**LAND USE APPLICATION SUMMARY**

*Property Location:* 100 Washington Avenue South  
*Project Name:* 100 Washington Square Addition and Plaza Improvements  
*Prepared By:* Lisa Steiner, City Planner, (612) 673-3950  
*Applicant:* Shorenstein Realty Services  
*Project Contact:* Jason Stiefel, Shea Architects  
*Request:* To enclose a portion of the existing open-air first floor, reconstruct the plaza area, and install a new sign.

<b>Variance</b>	Of the plaza development standards to reduce required seating and the required number of trash receptacles.
<b>Variance</b>	To increase the maximum allowed area of a freestanding sign.
<b>Site Plan Review</b>	For an approximately 4,000 square foot addition.

**3 ENLARGED EXTERIOR BUILDING SIGN ELEV.**  
SCALE: 1/4" = 1'-0"

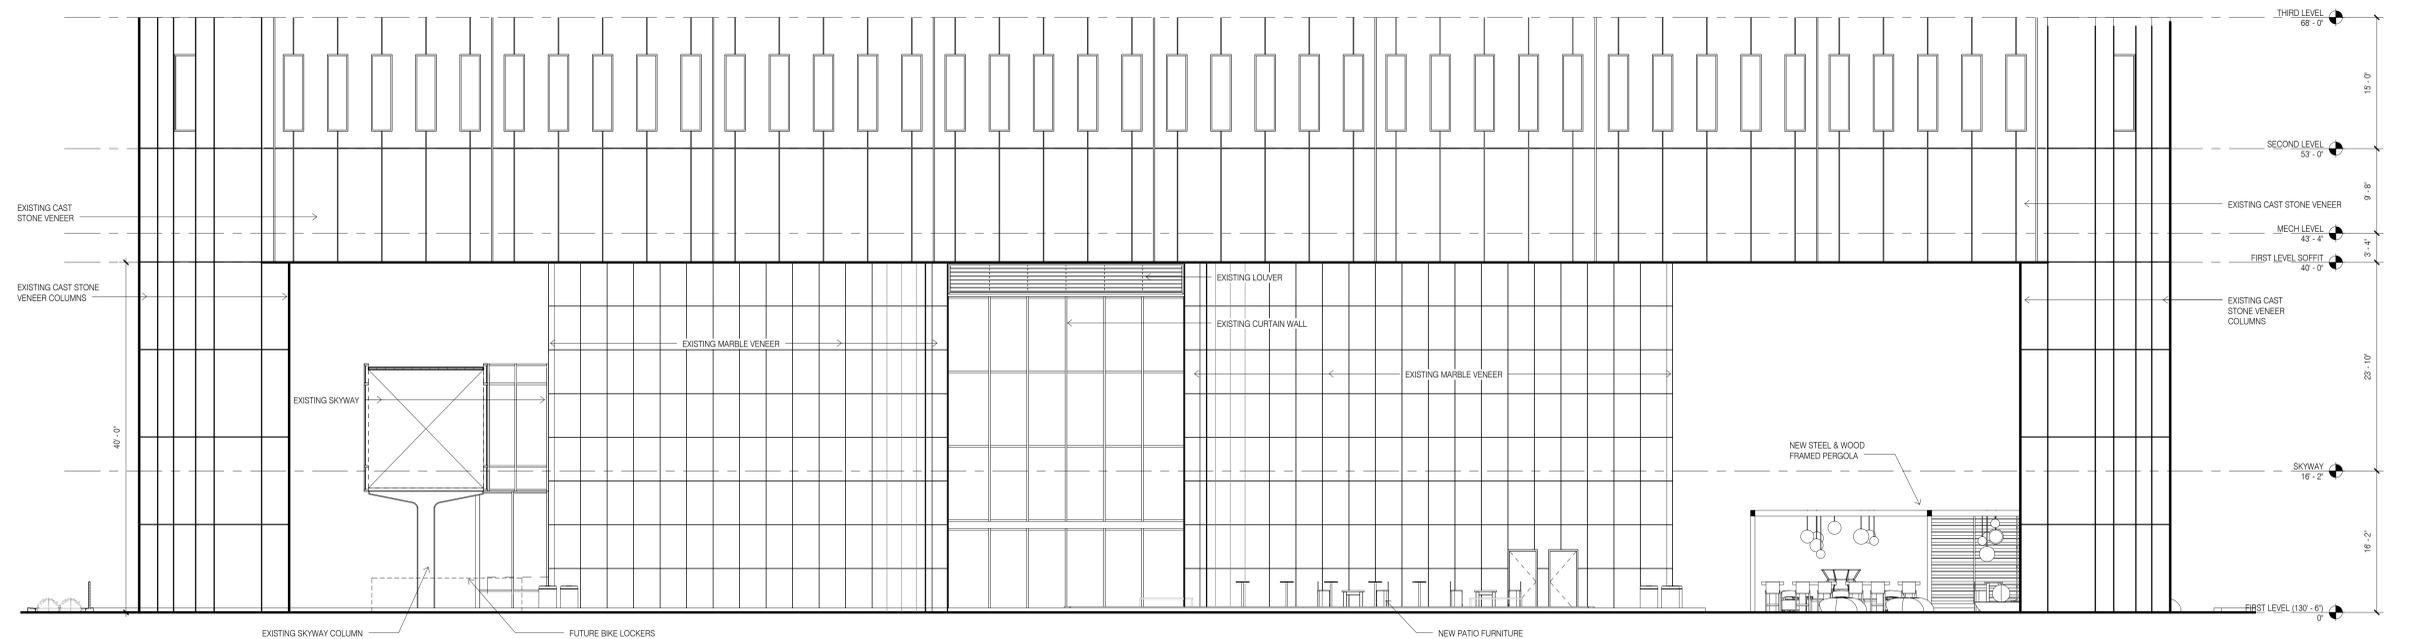
Staff does not find the proposal to install a 120 square foot freestanding sign to be reasonable. There are multiple reasonable alternatives for identification of the building that would be permitted by the zoning code. Regulations governing on-premises signs are established to allow effective signage appropriate to the planned character of each zoning district, to promote an attractive environment by minimizing visual clutter and confusion, to minimize adverse effects on nearby property, and to protect the public health, safety and welfare. Urban design policies in the comprehensive plan include promoting an attractive environment by minimizing visual clutter and confusion caused by a proliferation of signage. Effective signage can be reasonably achieved for this building while complying with the zoning code sign regulations.

- Note that the sign proposed is 150 square feet in area, not 120 square feet as noted. The sign area is determined by drawing a rectangle around the outermost dimensions of the sign. (Zoning Code Section 543.70). The maximum area of monument signs permitted in the Downtown Districts is 32 square feet.

○ - PARKING LOT SCREENING FENCE ELEVATION  
 - 1/4' = 1'-0"

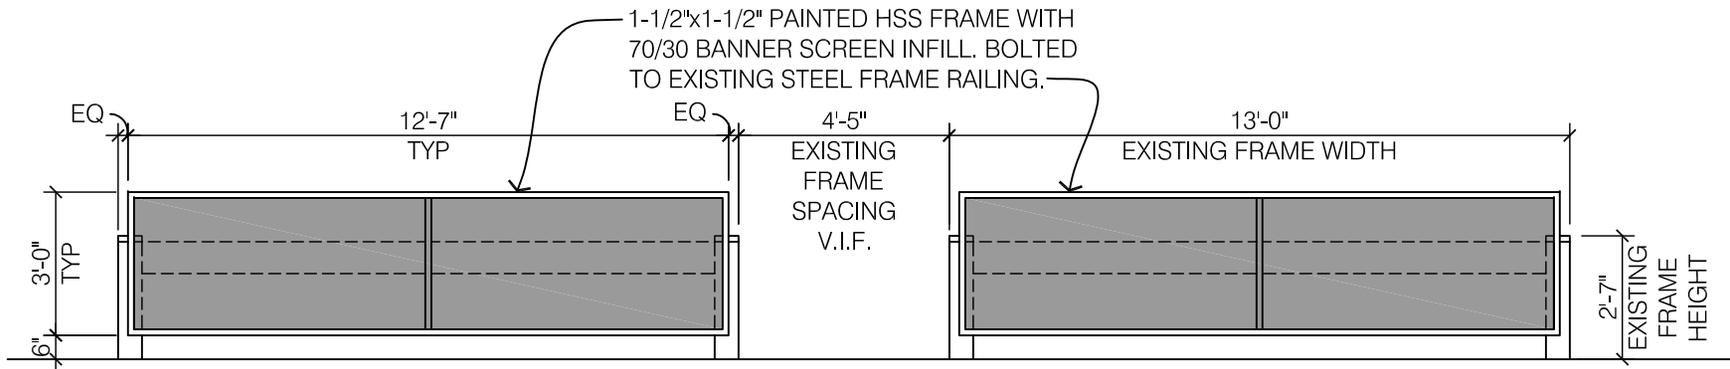
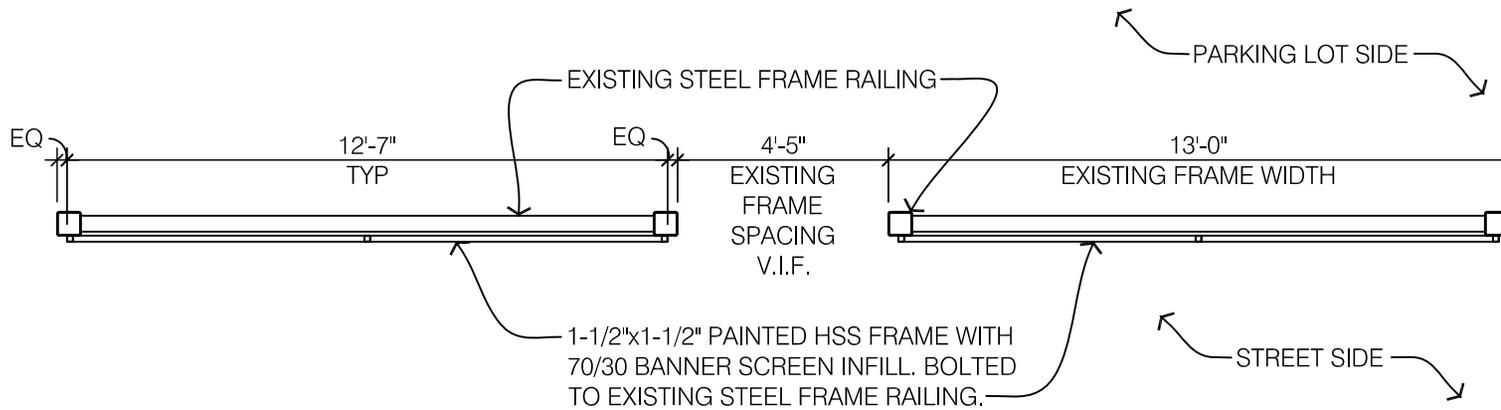
This material is not durable and would not be considered to be a “masonry wall, fence, berm or hedge or combination thereof” as required by the site plan review standards. This type of material merely gives a false impression of landscaping, is more suited to temporary construction site screening, and does not meet the intent of the ordinance. Also, per section 535.430 of the zoning code, fences shall be constructed of wood, metal, bricks, masonry or other permanent materials designed for permanent fencing. The vinyl mesh banner proposed does not meet the requirements for fencing material.

Additionally, because the screening is triggered by the adjacent residential use, but there is a private street which separates the two, staff considers it reasonable that screening be only 60% opaque, as would be required if the parking was adjacent to a public street. As stated above, staff is recommending that the steel railings which obstruct the walkway be removed. Screening may be achieved through ground-level plantings or planter boxes placed either at sidewalk level or at the parking area level. This may require restriping of the north parking spaces.

1. A seven-foot landscaped yard with screening at least three feet in height and sixty percent opaque shall be incorporated along the parking lot frontages on Marquette Avenue and 2<sup>nd</sup> Avenue South, as required by Section 530.170 of the zoning code.
2. The steel railings which obstruct on-site pedestrian access shall be removed. Screening at least three feet in height and sixty percent opaque shall be incorporated along the parking lot frontage on 2<sup>nd</sup> Street South.
3. CPED staff review and approval of the final site, elevation, lighting, and landscaping plans before building permits may be issued.
4. All site improvements shall be completed by July 6, 2017, unless extended by the Zoning Administrator, or the permit may be revoked for non-compliance.
